ADDENDUM #2

CLIENT
PEI Department of
Transportation
Infrastructure & Energy

PROJECT TITLE
Englewood School
Boiler Replacement
Propane Option

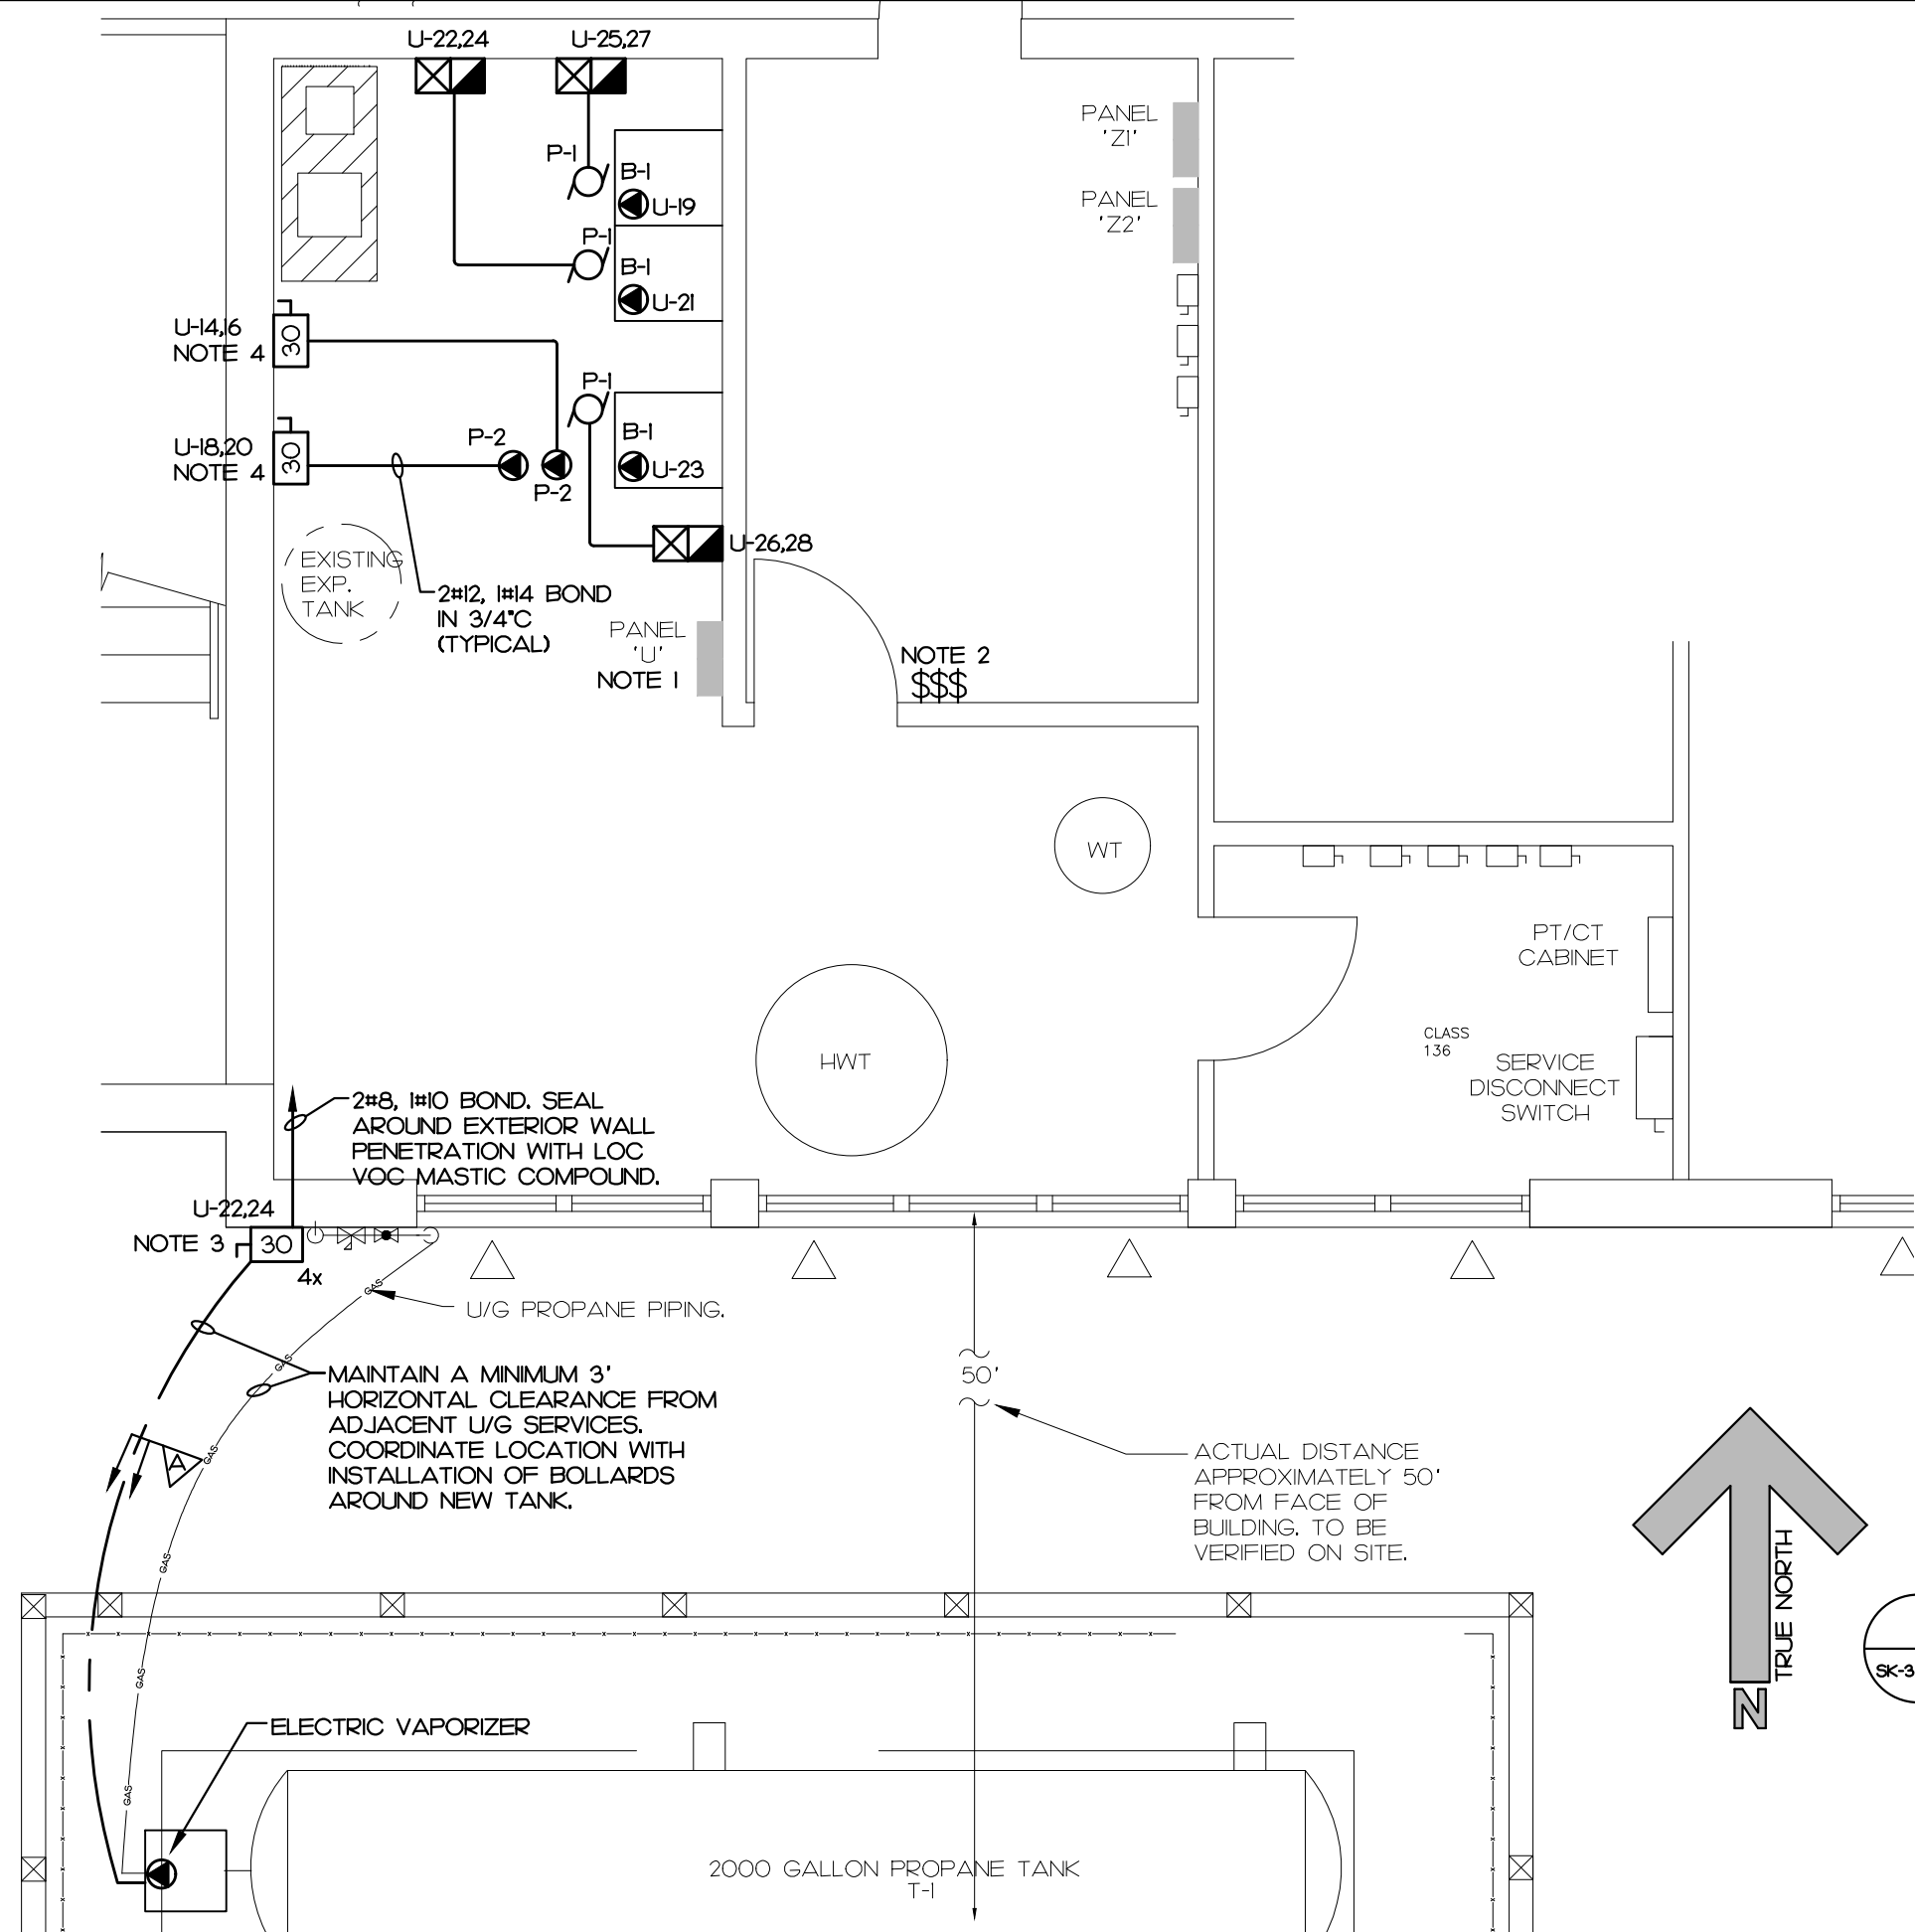
1. Reference New Sketches:
 - .1 See sketches SK-1, SK-2, SK-3, and SK-4, attached to and forming part of this addendum, for associated electrical work.

- NOTES:**
1. TRACE OUT, DISCONNECT, AND REMOVE ALL EXISTING ELECTRICAL ASSOCIATED WITH THE BOILER AND ASSOCIATED CIRCULATION PUMPS. EXISTING PANELBOARD AND BRANCH CIRCUIT BREAKER IN PANELBOARD TO REMAIN FOR FUTURE USE.
 2. TRACE OUT, DISCONNECT AND RELOCATE EXISTING REVERSE ACTING THERMOSTAT AND BRANCH CIRCUIT WIRING AS REQUIRED TO ACCOMMODATE NEW OIL BOILERS. COORDINATE EXACT LOCATION FOR REVERSE ACTING THERMOSTAT ON SITE WITH OWNER.

2 COMBINATION MAGNETIC MOTOR STARTER FOR PUMPS 'P-1'
 SK-4 SK-4 NTS

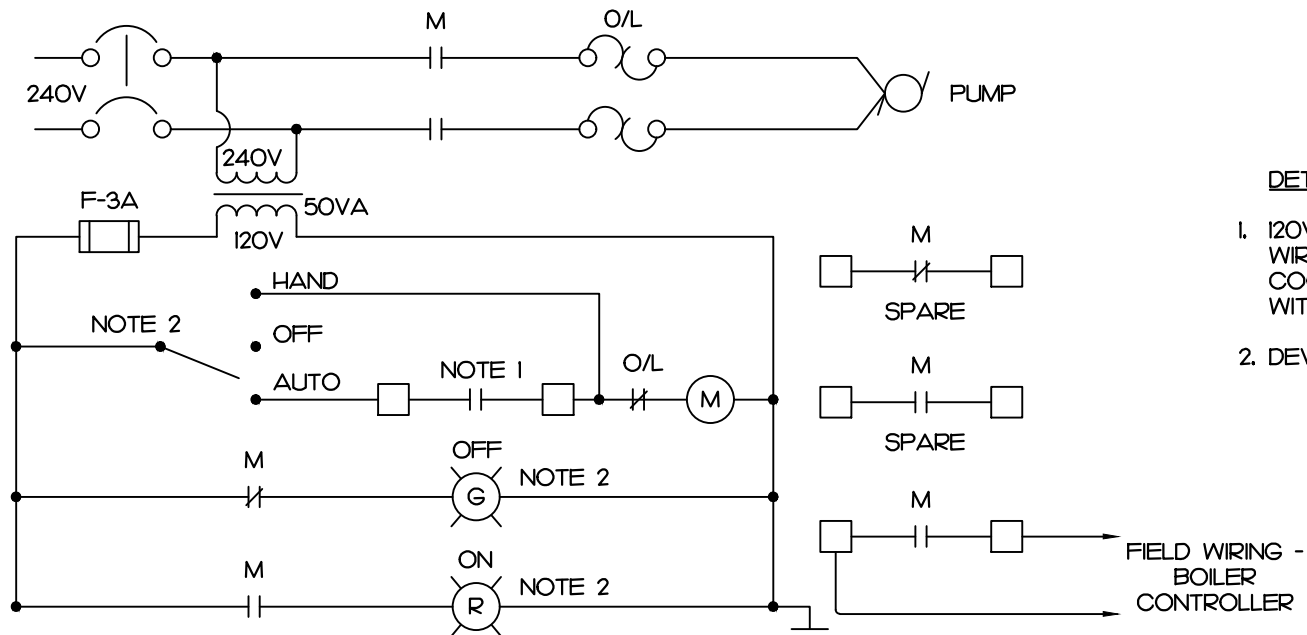
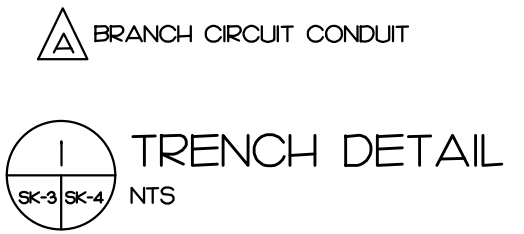
- DETAIL NOTES:**
1. 120V SWITCHING OUTPUT FROM BOILER CONTROLLER TO BE WIRED TO CONTACTOR BY ELECTRICAL CONTRACTOR. COORDINATE CONNECTION AND EXACT TERMINATION POINT WITH BOILER CONTRACTOR.
 2. DEVICE TO BE FRONT COVER MOUNTED.
